Re: Abatement Plan, PacifiCorp, Des-Bee-Dove Mine, ACT/015/017-92C, Folder #2,
Emery County, Utah

DES BEE DOVE LOWER BELTED ROAD DRAINAGE

RE: ABATEMENT DEFICIENCIES FOR NOV 91-20-2-1, PART 1, PACIFICORP,
DES-BEE-DOVE MINE, ACT/015/017

DBD LOWER BELTED ROAD DRAINAGE

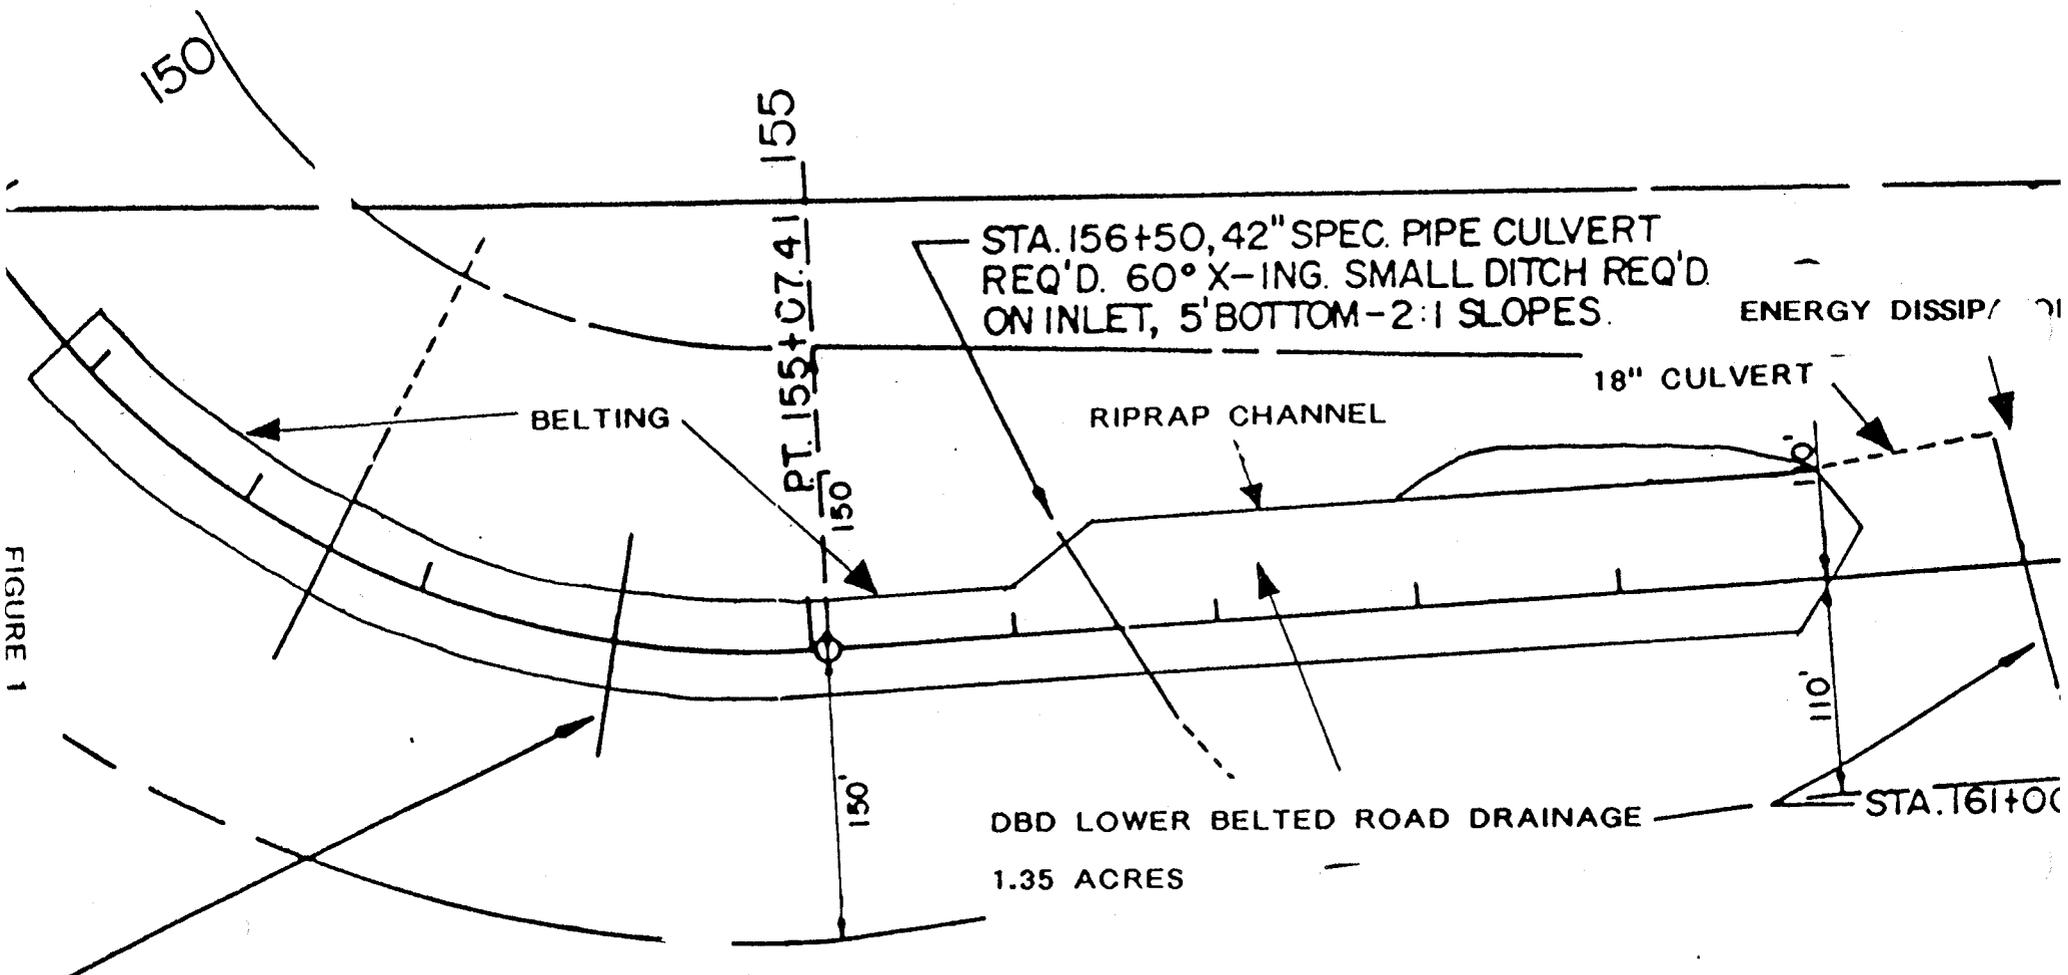
- 4. **The operator must submit a map of appropriate scale (1"=100") which shows the location of the watershed, channel, culvert and rock lined basin.**

The scale and energy dissipator has been added to Fig. 1. The watershed, channel and culvert were previously shown on Fig. 1.

DES-BEE-DOVE MINE
CHANNEL AT
STA 156 TO 161

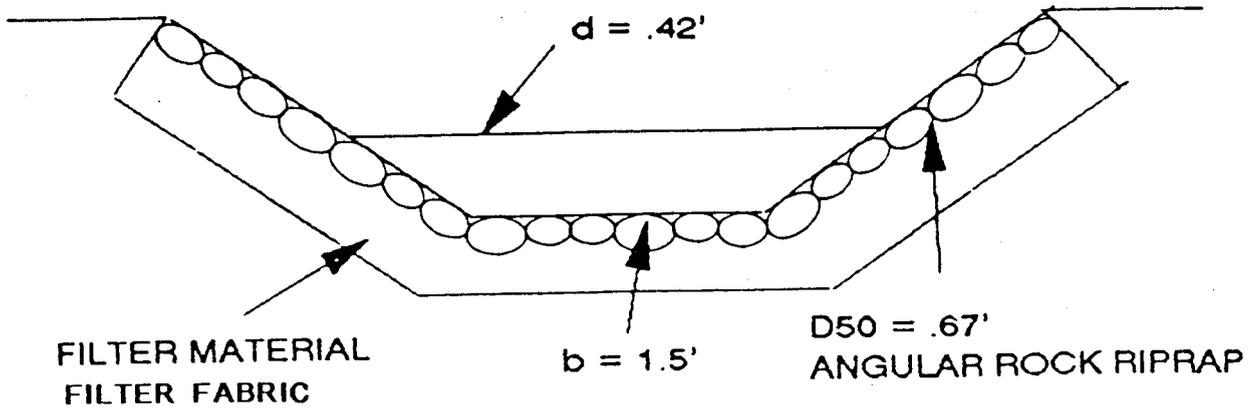
- 1. **The operator failed to provide a gradation for his riprap. Provide the D100 and D20 sizes for the channel design.**

Riprap gradation has been added to the drainage design.

FIGURE 4

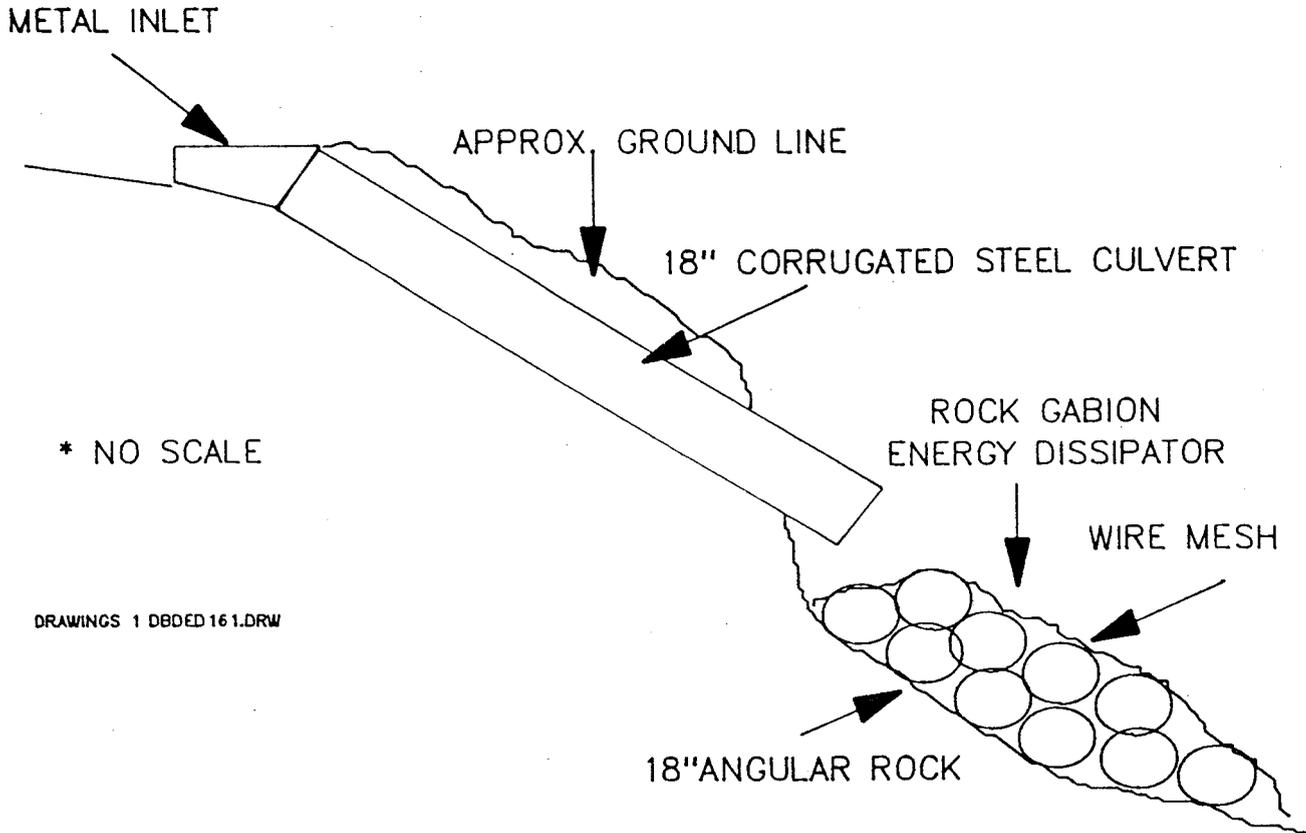
- 2. **The installation of the culvert does not include any design specifics for the installation of the culvert (i.e., buried or installed on the surface, headwall dimensions).**

This information is shown in Fig. 4. The inlet to the culvert is a standard flared metal end-section. The culvert will be buried approximately 12" as shown.
